Mecklenburg County
Health Department

RE: Property located at Brief Road
FILE: 7120A
PARCEL: 139-302-15PO

MECKLENBURG COUNTY HEALTH DEPARTMENT
SITE EVALUATION REPORT
SERIAL NUMBER 16829

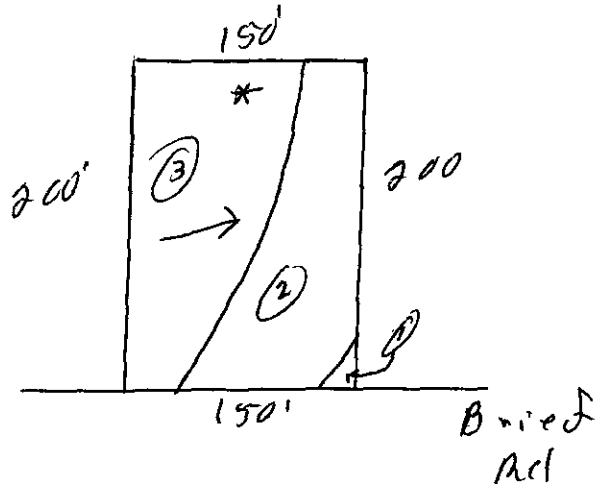
Comments: 100% Repair
* Extremely Heavy Expanding clay boring - recommend backhoe investigation if system is proposed for lot

FACTORS	AREA 1	AREA 2	AREA 3	AREA 4	AREA 5	AREA 6
Topography	(S) PS U 2-6%	S PS (U) Depression	(S) PS U 2-10%	S PS U	S PS U	S PS U
Texture	S (PS) U Clay	S PS U —	S (PS) U clay	S PS U	S PS U	S PS U
Structure	S (PS) U Blocky	S PS U —	S (PS) U Blocky	S PS U	S PS U	S PS U
Drainage	S (PS) U 7 36" TO water	S PS U —	S (PS) U 7 36" TO water	S PS U	S PS U	S PS U
Depth	S (PS) U 36-38"	S PS U —	S PS (U) 15-30"	S PS U	S PS U	S PS U
Restrictive Horizons	S (PS) U 7 36"	S PS U —	S (PS) U 7 36"	S PS U	S PS U	S PS U
Available Space	S PS (U) Restricted	S PS U —	S (PS) U limited	S PS U	S PS U	S PS U
Other (specify)	S PS U	S PS U	S PS U	S PS U	S PS U	S PS U
Soil Group/Series	IV Cecil/Tatum ~~Cecil/Tatum~~	Depression	IV Badin-Lilly			
Area Classification	S PS (U)	S PS (U)	S PS (U)	S PS U	S PS U	S PS U
